04V-472

G-04518-R2
April 2005

SUBJECT: SAFETY RECALL (U.S., EXPORT)
TURN SIGNAL SWITCH assemblies on certain 3300,
4200, 4300, 4400, and CE School Bus models built
5/24/2004 thru 8/17/2004

Figure 4

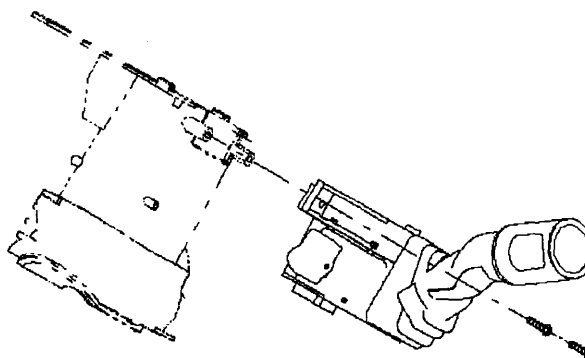
- Added steps 7a and 7b.

7. Install new switch assembly and connect electrical connector. See **Figure 4**.
 - a. If the vehicle has a Blue Bird body, use **2589451C91**.
 - b. For all other vehicles and bus bodies, use **3587009C91**.
8. Perform functional test on switch to verify all turn signals and hazard lamps function.
9. Re-install upper and lower steering column trim panels. See **Figure 1**.
